REMARKS

Sheet 2 of 6 Appl. No. 09/696,525 Amdt. dated September 29, 2004 Reply to Office action of May 4, 2004

FIG. 2B

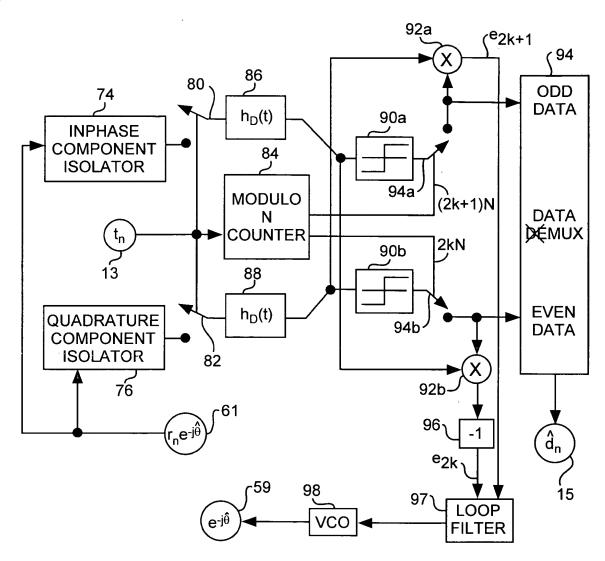
Annotated Sheet Showing Changes
